SERVICE BULLETIN

M-1208B

Safety Recall Code 0131

2006-2007 XL EXHAUST SHIELD RECALL

Figure 1. Inner Exhaust Shield Installation on Rear Exhaust Pipe

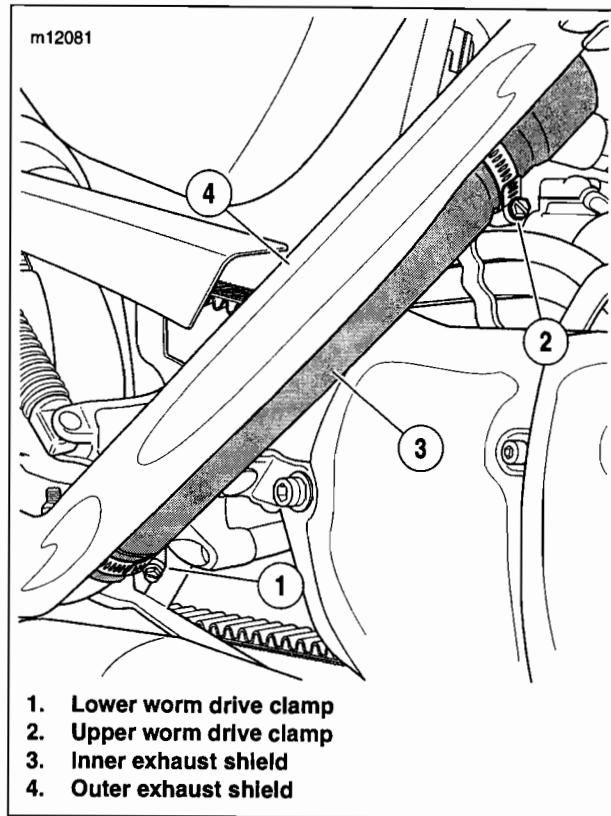
Harley-Davidson has determined that a condition affecting motor vehicle safety exists on selected 2006 and 2007 XL model vehicles. These vehicles have a condition whereby the pant leg of some riders can have direct contact with the exhaust pipe. This condition could cause the pant leg to char or burn, which could lead to the possibility of injury to the rider.

In the interest of motor vehicle safety and customer satisfaction, Harley-Davidson has elected to initiate a voluntary recall (0131). Recall 0131 consists of installing an additional exhaust shield on the inner side of the rear exhaust pipe, preventing the risk of the rider pant leg having direct contact with the exhaust pipe. You may sell **but not deliver** any affected motorcycles to your customers until the remedy is completed.

See Figure 1. If the vehicle is equipped with an original rear exhaust pipe (header) which does not have the inner exhaust shield installed, proceed to the installation instructions.

1. See Figure 1. Loosen the lower worm drive clamp (1) on the rear exhaust pipe.
2. Loosen the upper worm drive clamp (2).
 - a. See Figure 2. On 2006 model vehicles, loosen the upper worm drive clamp. Rotate the clamp (1) to accommodate the installation of the inner exhaust shield as shown.
 - b. On 2007 model vehicles, completely unfasten the upper worm drive clamp until the clamp opens.
3. See Figure 1. Slide the bottom portion of the **new** inner exhaust shield (3) against the exhaust pipe and into the lower clamp. The clamp should rest on the indented portion of the inner exhaust shield.

4. Tighten lower clamp securely.
5. Place the upper portion of the inner exhaust shield against the exhaust pipe.
6. Install the upper worm drive clamp(s).
 - c. See Figure 2. On 2006 model vehicles, install a **new** worm drive clamp (Part No. 9955) on the indented portion of the inner exhaust shield. Tighten both upper clamps securely.
 - d. See Figure 1. On 2007 model vehicles, install the upper clamp over the indented portion of the inner exhaust shield. Tighten clamp securely.
